09/182842

BEHL1318

attch
to #9
Drift #

FIG.-1
(PRIOR ART)

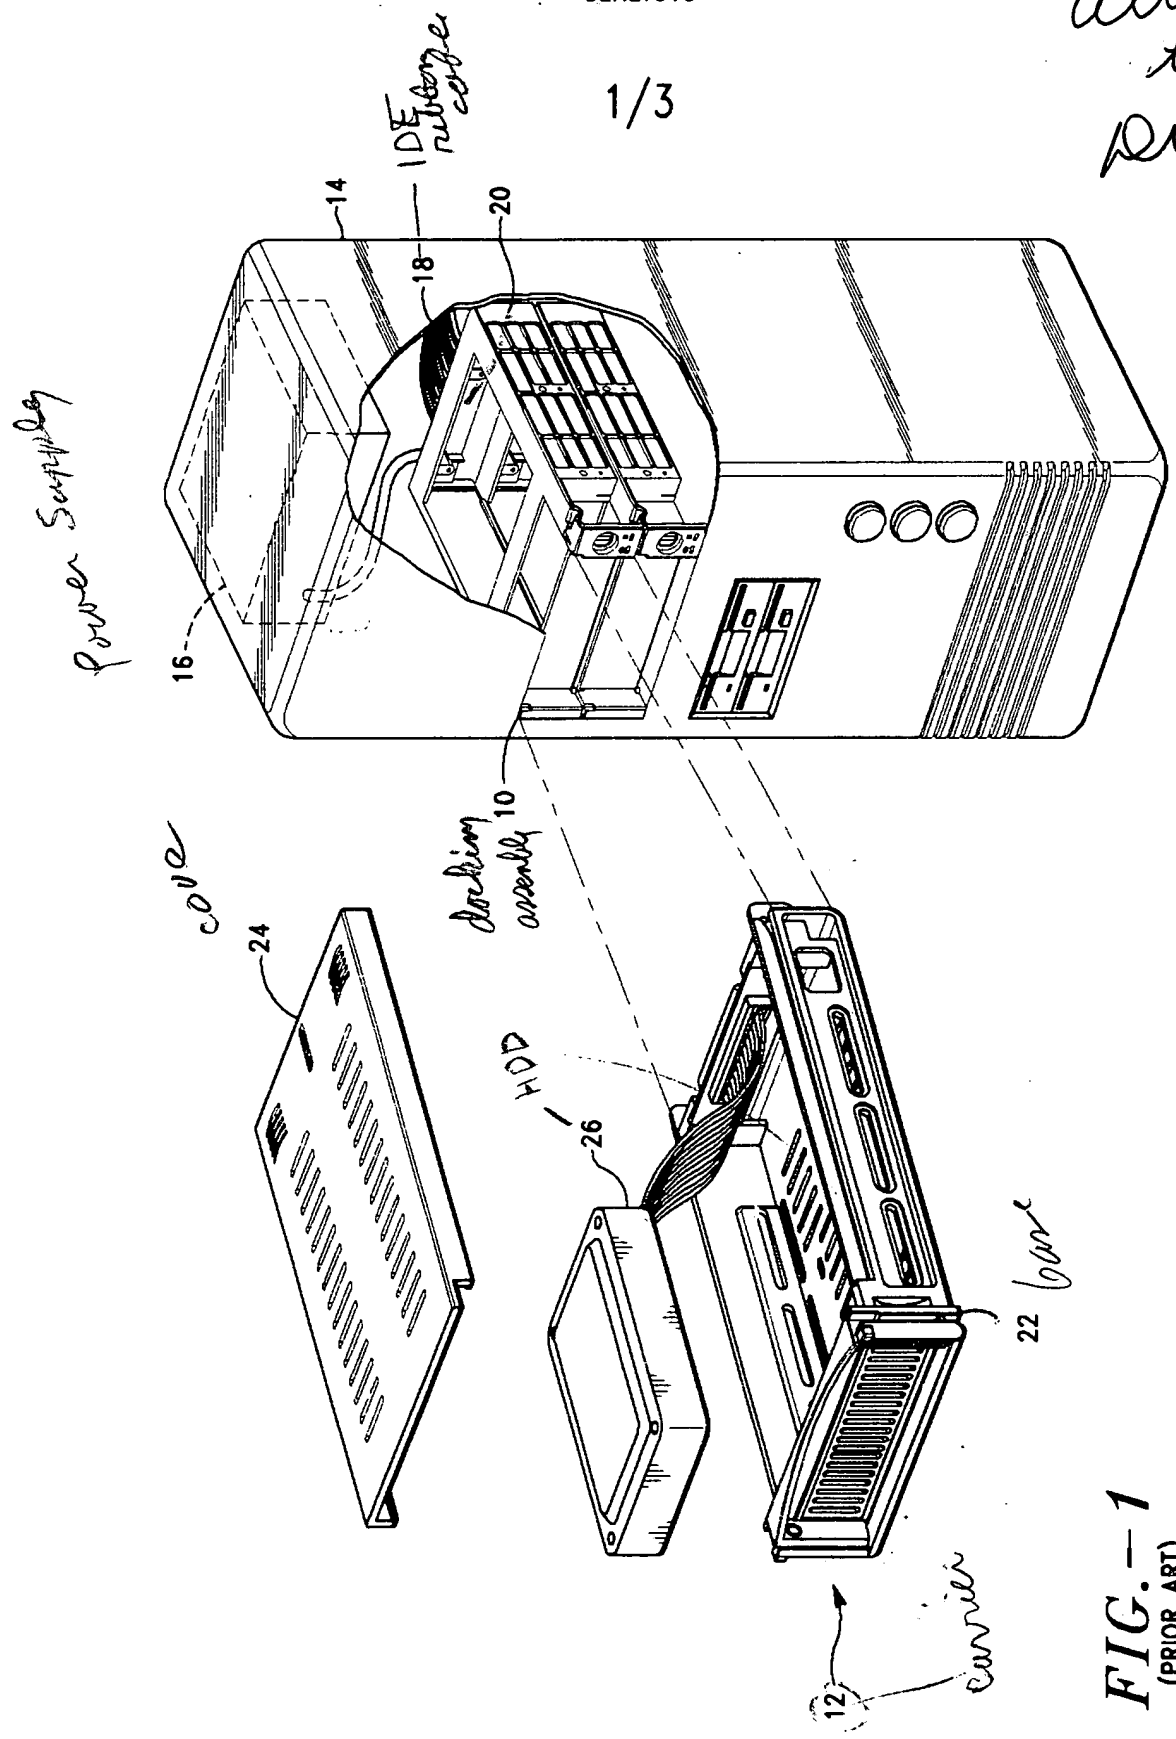
Approved
except
as noted
22

plug not the locking assembly

FIG.-2

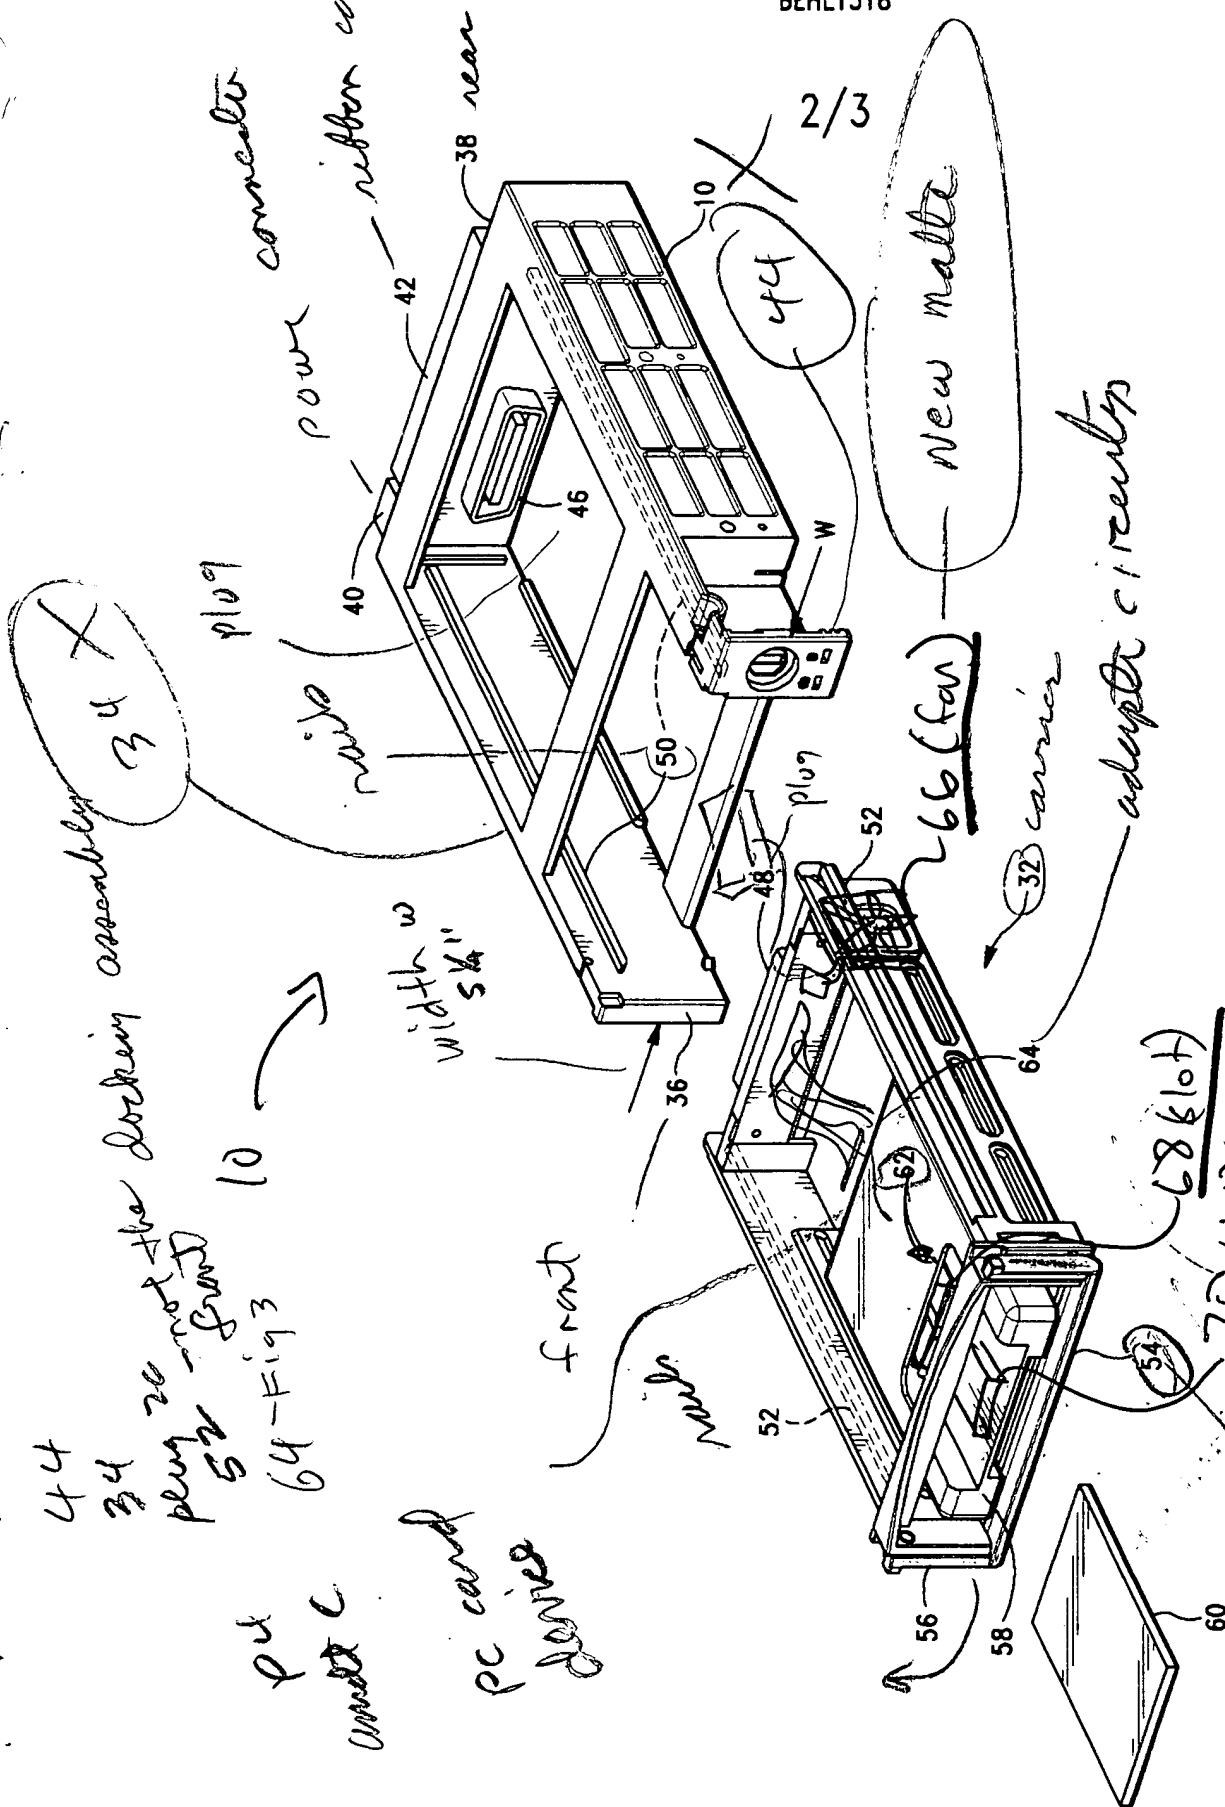
offset slots

handle

new matter

FIG.-3

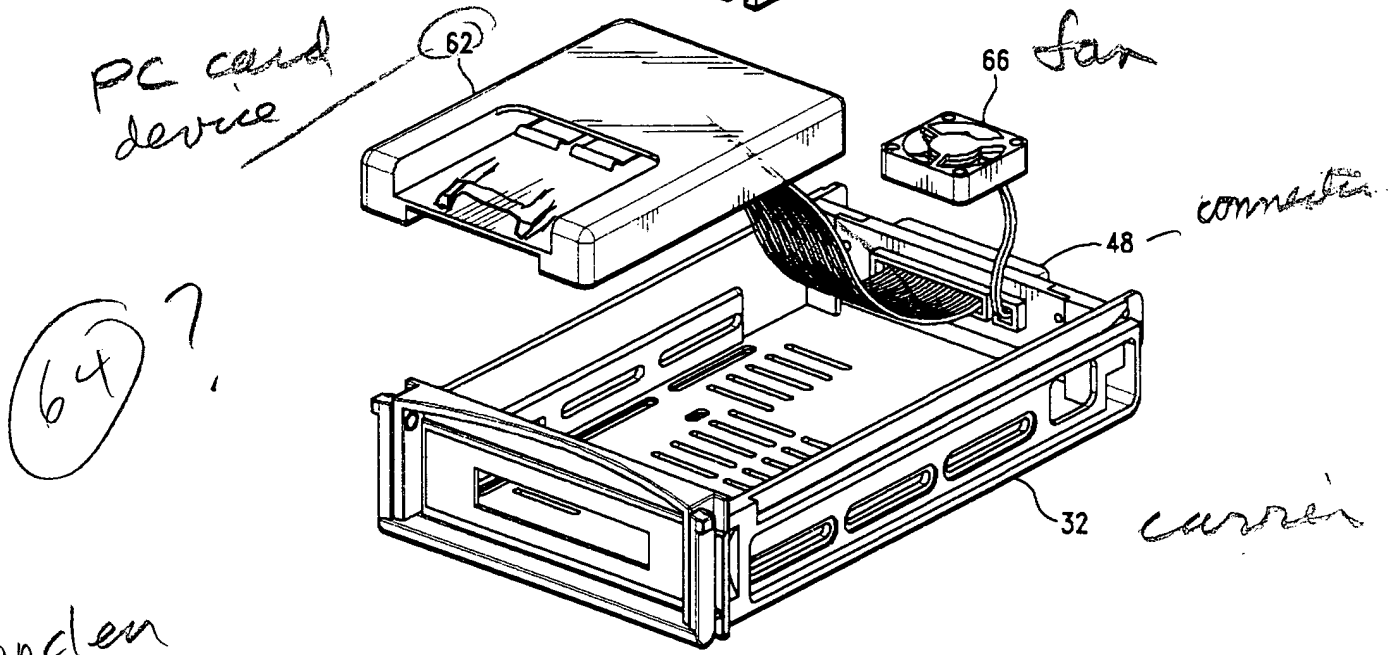
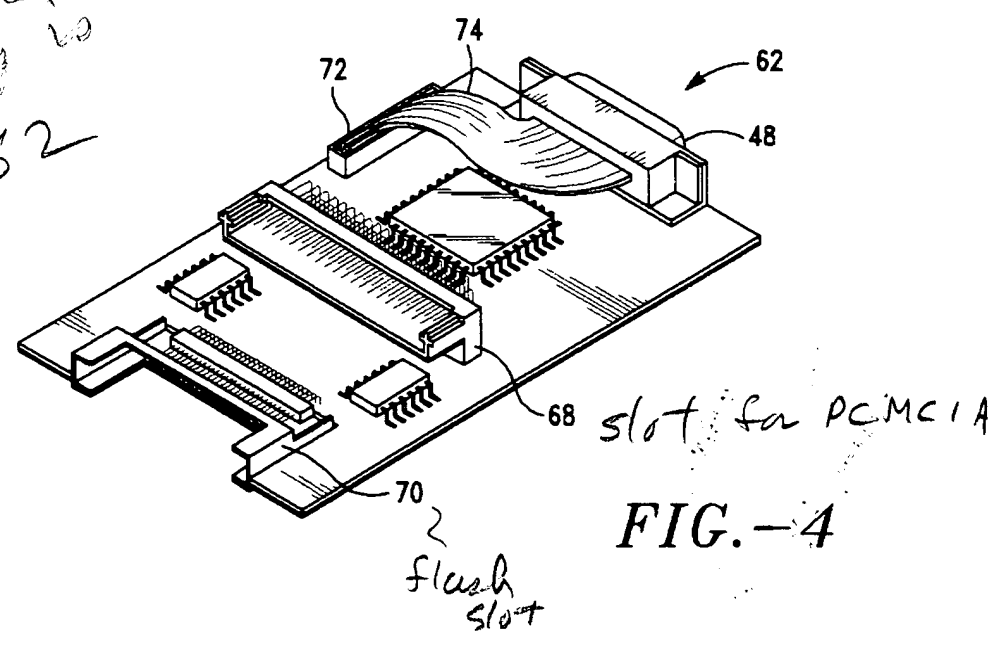
Under
if 48 is in
carrier 32 in
fig 3, why is
it on part 62
in fig 4
